FINAL ENVIRONMENTAL IMPACT REPORT FOR THE LOS ANGELES AERIAL RAPID TRANSIT PROJECT LOS ANGELES, CALIFORNIA

December 2023

Los Angeles County Metropolitan Transportation Authority

Kimley-Horn

LA ART | Segment of Proposed Alignment Profile with Homeboy Industries' Proposed Future Development at 903 North Main Street
SCALE: 3/16"=1' | 4/13/2023

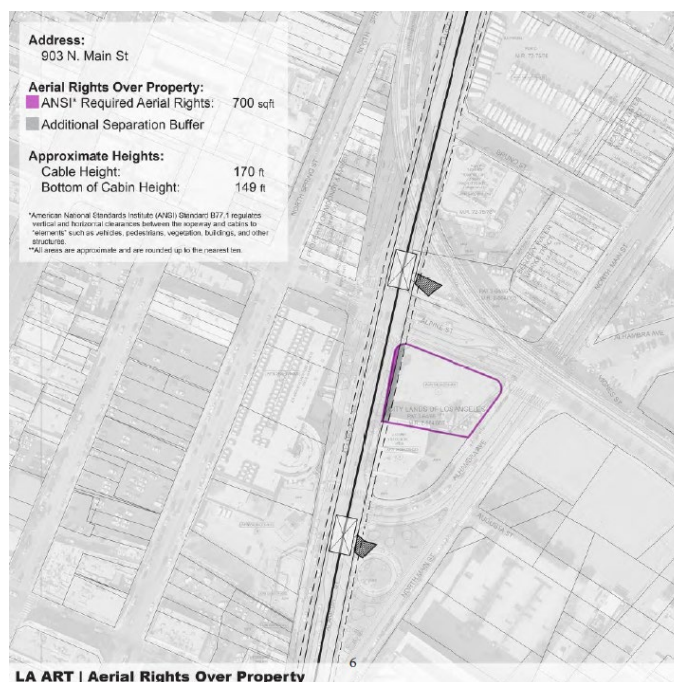
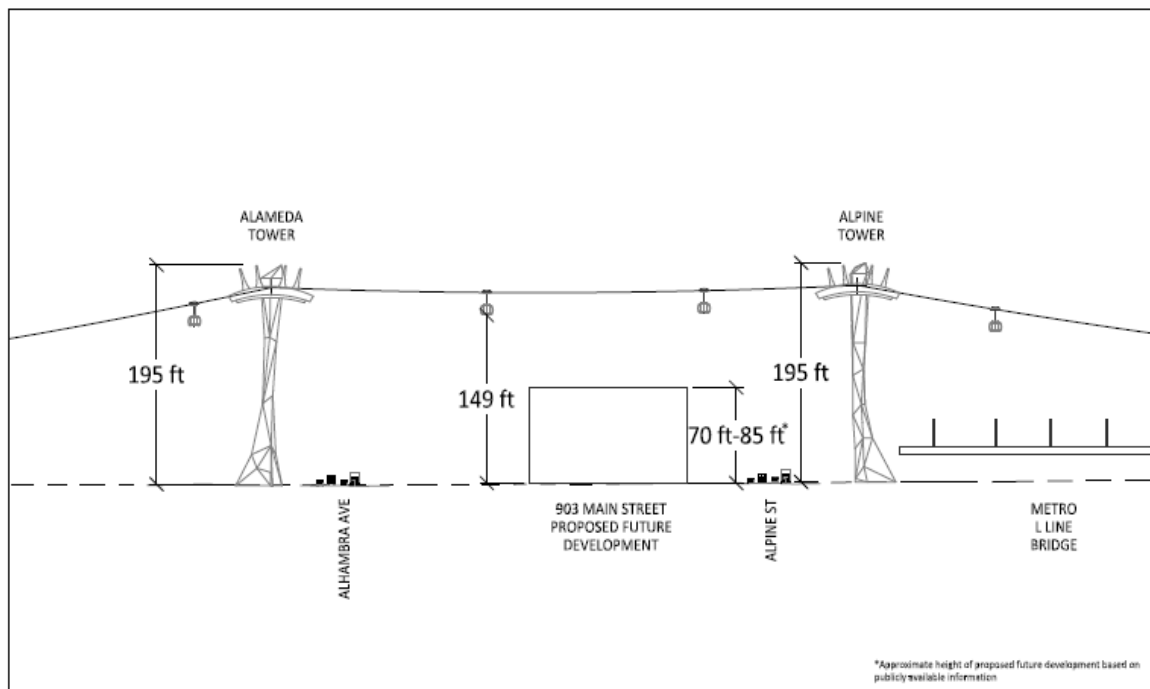
The proposed Project is anticipated to require approximately 700 square feet of ANSI required aerial rights over 903 North Main Street, plus an Additional Separation Buffer.³⁸ Based on the publicly available information, Homeboy Industries' anticipated housing project at this location would be five stories. Based on the publicly available renderings on KFA Architect's website, Homeboy Industries' housing project appears to be Type III or Type V construction over a podium and appears to be approximately 70 feet high, and would be unlikely to exceed approximately 85 feet, which is the typical maximum height for Type III or Type V construction. ANSI B77.1 requires a vertical clearance of at least five feet over buildings. The proposed Project was designed to ensure that this clearance is met, as the bottom of the cabins would be 149 feet above ground and the cable would be 170 feet above ground. Accordingly, there would not be a conflict between Homeboy Industries' anticipated housing project and the required aerial clearances for the proposed Project. The proposed Project would substantially exceed the required aerial clearances from Homeboy Industries' anticipated housing project and would not impact either its construction or operation. The following segment of the proposed alignment's profile between Alameda Tower and Alpine Tower illustrates the proposed Project's relationship to Homeboy Industries' anticipated housing project, significantly exceeding the required clearances based on the publicly available information regarding Homeboy Industries' housing project.

Figure 1: Traffic simulation results by the hour

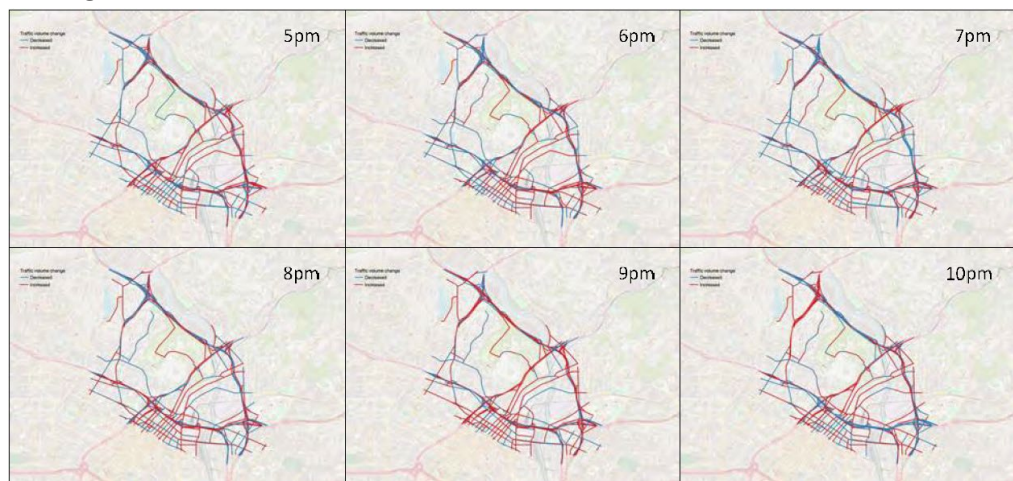
- Contrary to claims from LA ART, researchers found that the gondola would not significantly reduce traffic around Dodger Stadium.** Results showed the gondola would likely slightly reduce traffic on some roads around the stadium for a sold-out night game and increase traffic on others, leading to little reduction in greenhouse gas emissions. The red lines in Figure 1 above indicate road segments that have a higher traffic volume after the proposed gondola is added to the traffic simulation. The blue lines indicate a decrease in traffic volume. According to the simulation, the total traffic volume would likely be reduced by around 0.9%

The graphic presented in Figure 1 of the Mobility Lab Study illustrates preliminary traffic simulation results from the Mobility Lab's model for the highway system in the vicinity of Dodger Stadium. The transportation model roadway network shown in Figure 1, however, shows that the Mobility Lab Study and model network is missing many of the critical roadways that link to Dodger Stadium (including Stadium Way, Vin Scully Avenue, Chavez Ravine Place, College Street, Bishops Road, the SR-110 ramps to/from the Dodger Stadium Downtown Gate, and the Dodger Stadium gates themselves). This is typical for regional travel demand models designed for analysis of the regional transportation system, which by design do not include smaller subregional streets or event venues. However, the missing streets play an important role in access to/from the stadium. A more sophisticated localized analysis of traffic increases and decreases in the vicinity of Dodger Stadium should include customization of the model's highway network to include an increased granularity of detail for the streets serving the stadium, as this network has a profound effect on congestion in the neighborhoods surrounding the stadium. The lack of roadway network customization in the Mobility Lab Study model to include the key roadways serving Dodger Stadium underreports the benefits of trip reductions around Dodger Stadium, because the roadways that access the Stadium are those where the full benefit of the proposed Project would be experienced. The omissions of these roadways from the Mobility Lab Study model renders any estimation of traffic reductions and/or increases to be incomplete and aligns with the Mobility Lab's own statement that their forecast for the proposed Project should be considered preliminary.
